DART AEROSPACE LTD	Work Order:	164 145
Description: Crosstube Assembly, Mid Aft	Part Number:	D206-667-247
Inspection Dwg: D206-667-247 Rev: A		Page 1 of 2

DART AEROSPACE LTD HAWKESBURY, ONTARIO, CANADA	
DRAWING NO. D206-667-247	REV. A
TITLE CROSSTUBE ASSY (206L MID AFT)	SCALE NTS

DRAWING NO. D206-667-247	TITLE CROSSTUBE ASS'Y (206L MID AFT)	REV. A	DART AEROSPACE LTD ENGINEERING ORDER		D.E.O. NO. D206-667-247-A-1	SHEET NO. SHEET 1 OF 1	SCALE NTS
DRAWN <i>q2</i>	CHECKED <i>ASS</i>	MFG. APPR. <i>AD</i>	APPROVED <i>IMP</i>	DE APPR. <i>H</i>			
DATE 11.07.15	DATE 11.07.20	DATE 11.07.21	DATE 11/07/21	DATE 11.07.21

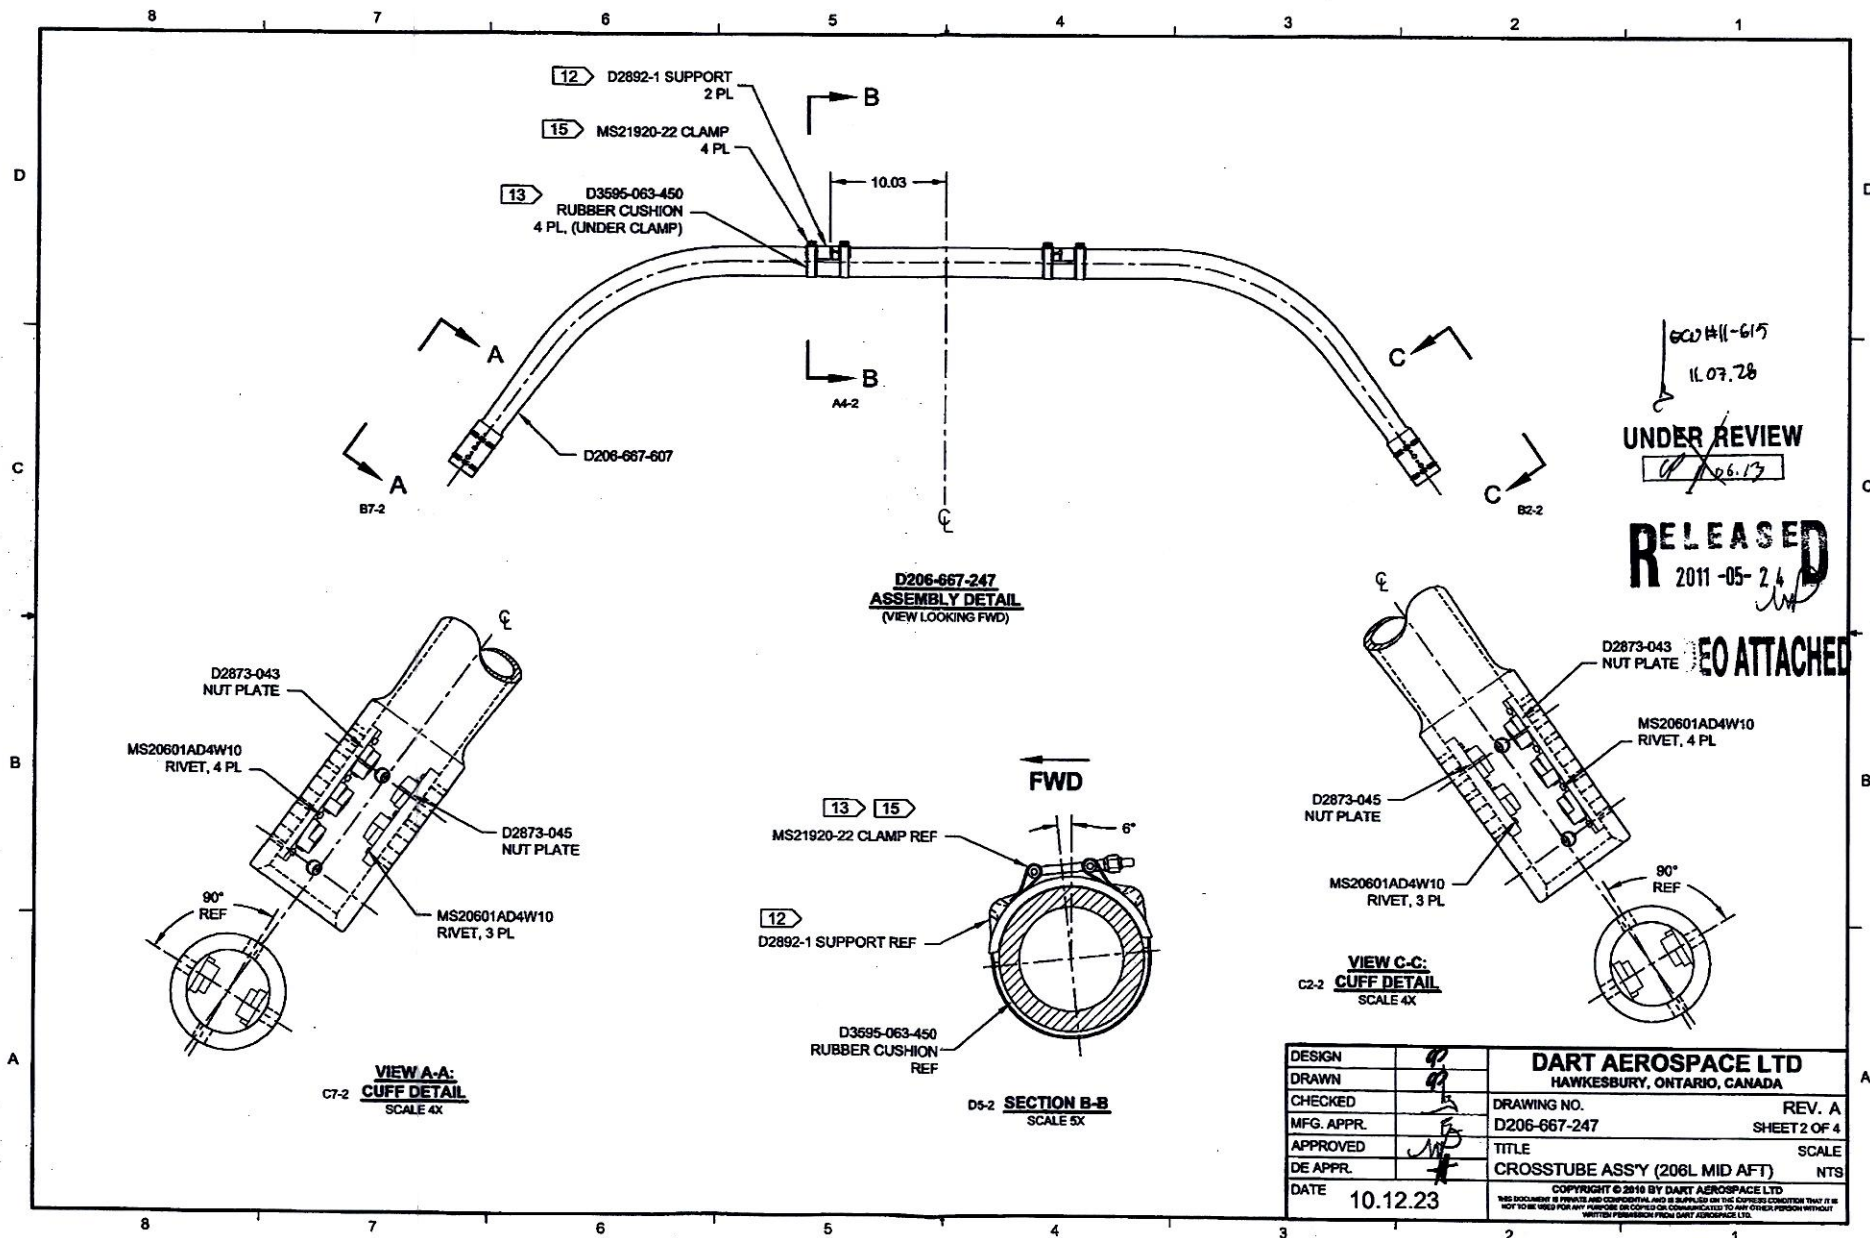
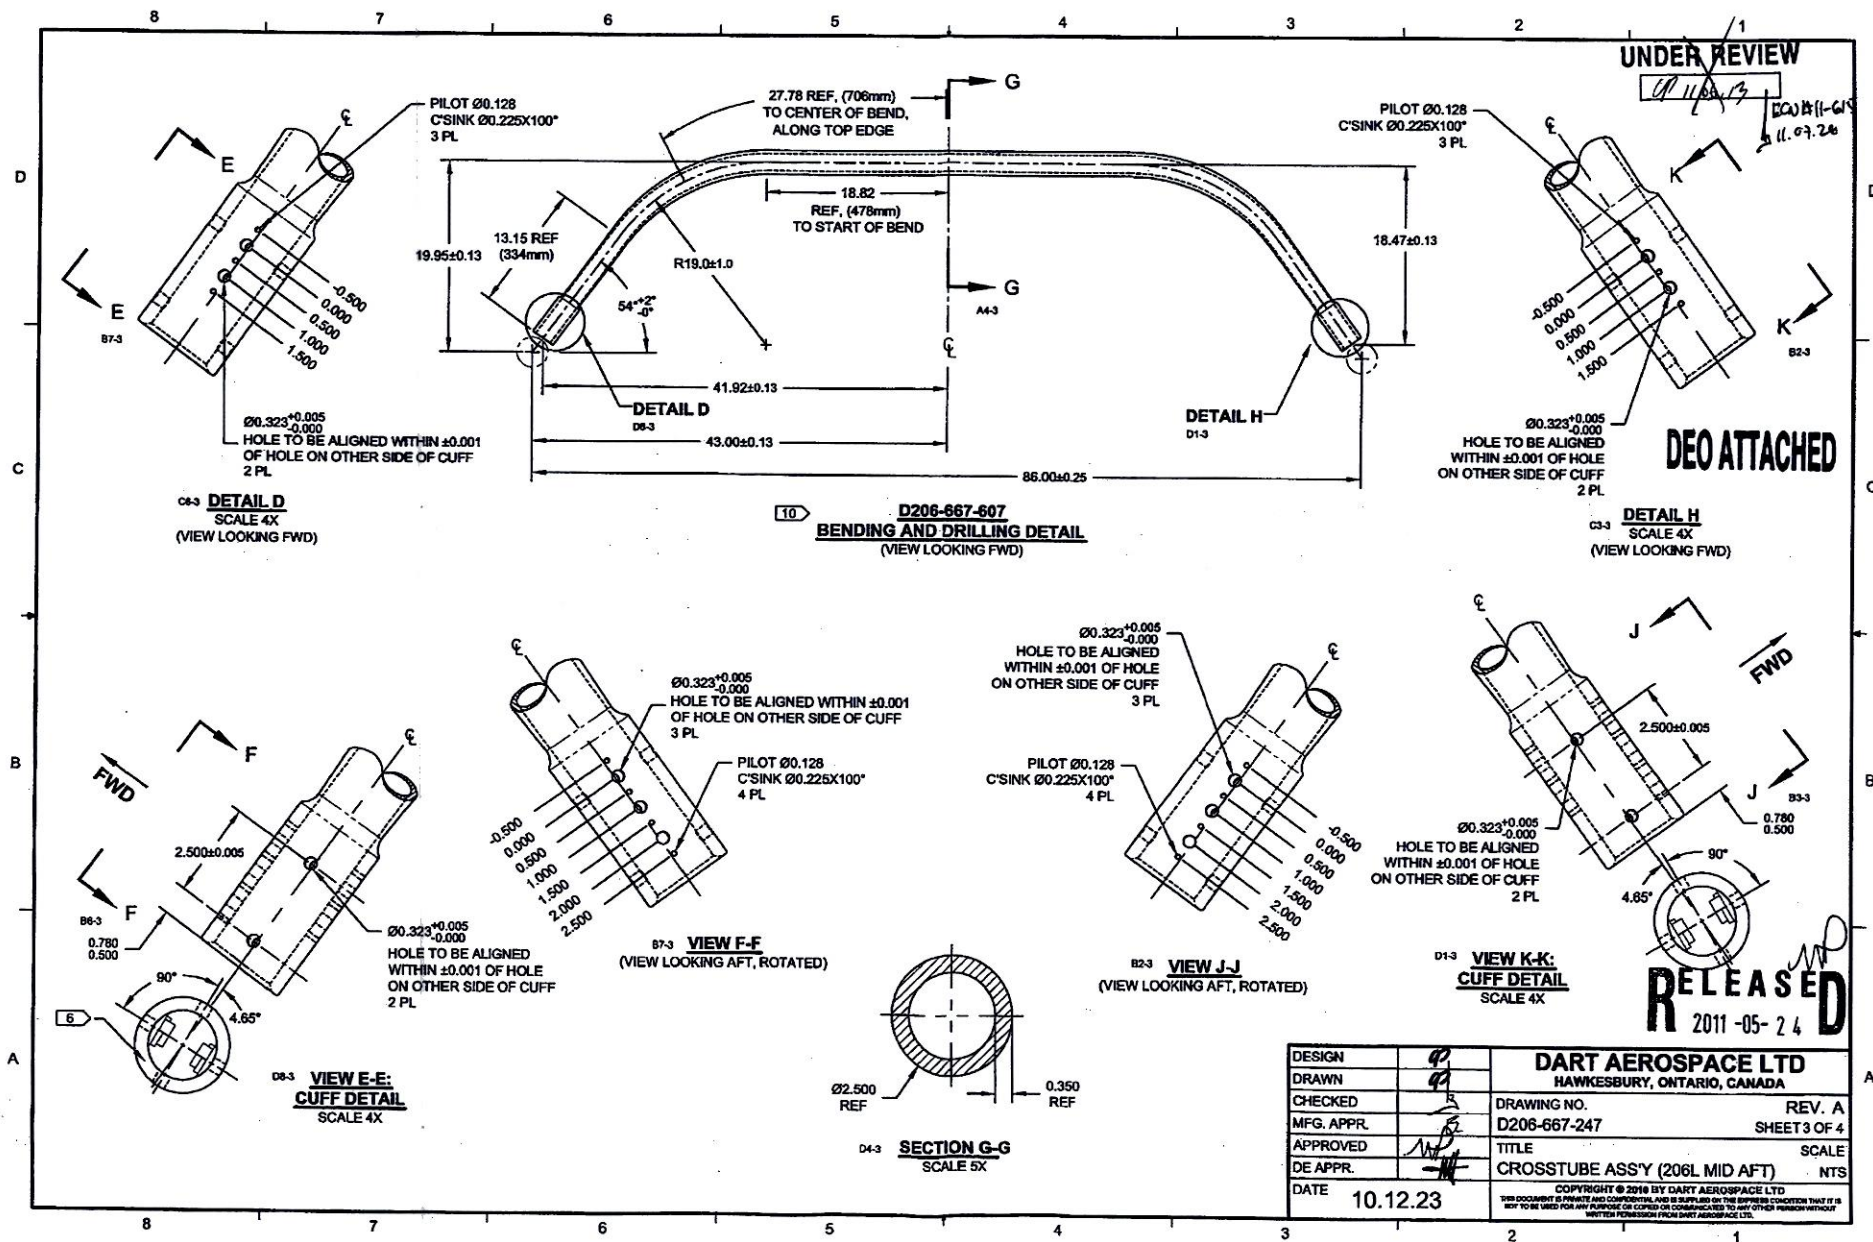
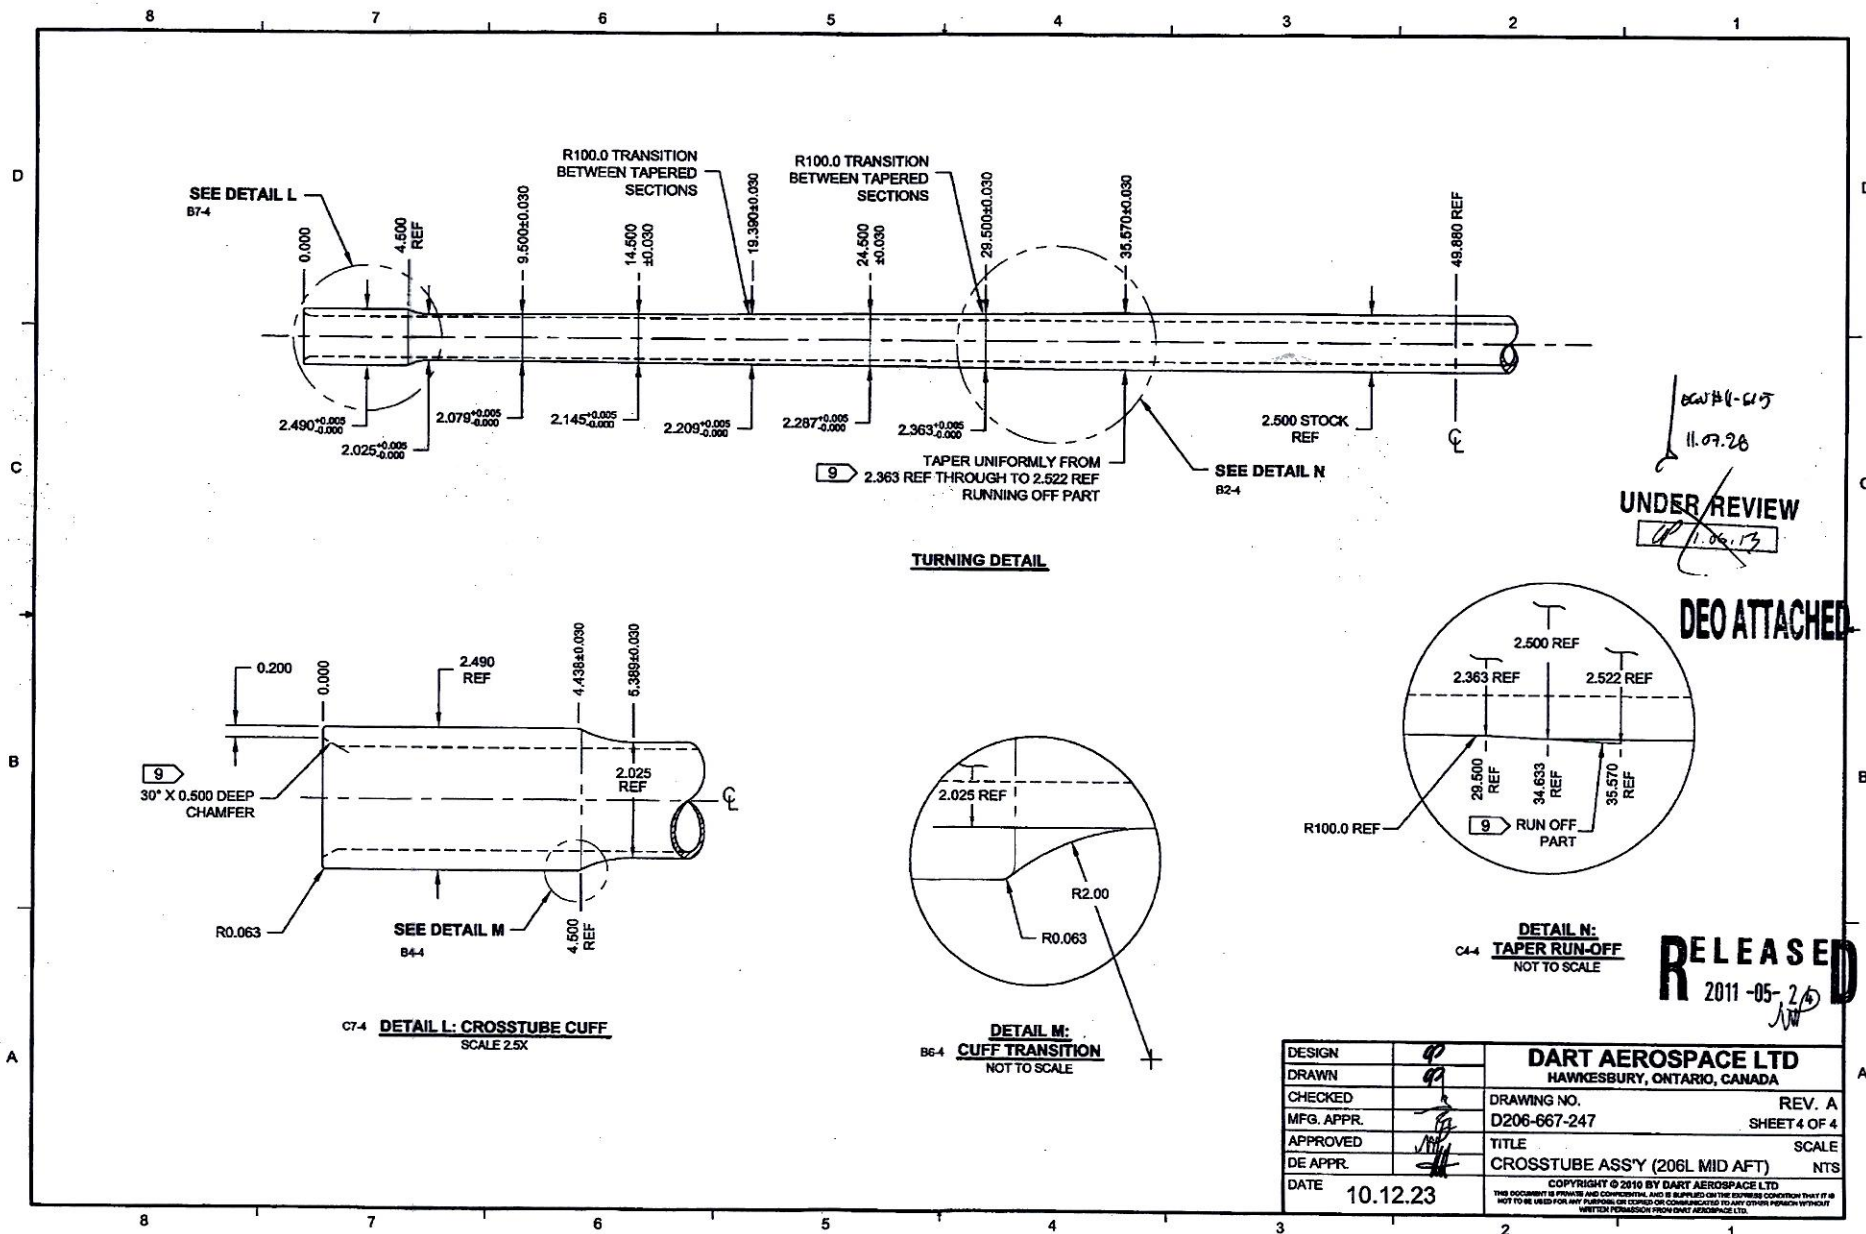
PURPOSE:

REPLACE MAGNOBOND WITH PROSEAL.

NOTE 12 & 15, SHEET 1 IS AMENDED AS FOLLOWS:

IS:

Item	Qty -247	Part Number	Description
9	A/R	PROSEAL 890 B-2	SEALANT, AMS-S-8802 CLASS B-2

IS:

- 12) TO INSTALL D2892-1 SUPPORT: ABRABE MATING SURFACE OF SUPPORT AND CROSSTUBE WITH 180-GRIT SANDPAPER AND REMOVE RESIDUE WITH MEK (OR EQUIVALENT). APPLY A 0.04" TO 0.07" THICK LAYER OF PROSEAL 890 CLASS B-2 (OR AMS-S-8802 CLASS B-2) SEALANT TO MATING SURFACE OF SUPPORT.
- 15) TORQUE CLAMPS 80 TO 100 IN-LB. ENSURE AT LEAST 1.5 THREADS SHOWING IN SAFETY AND THAT NUT HAS NOT BOTTOMED-OUT AFTER TORQUING. **PRIOR TO PACKAGING, RE-CHECK TORQUE ON CLAMPS AFTER PROSEAL 890 SEALANT HAS CURED FOR 72 HOURS.**
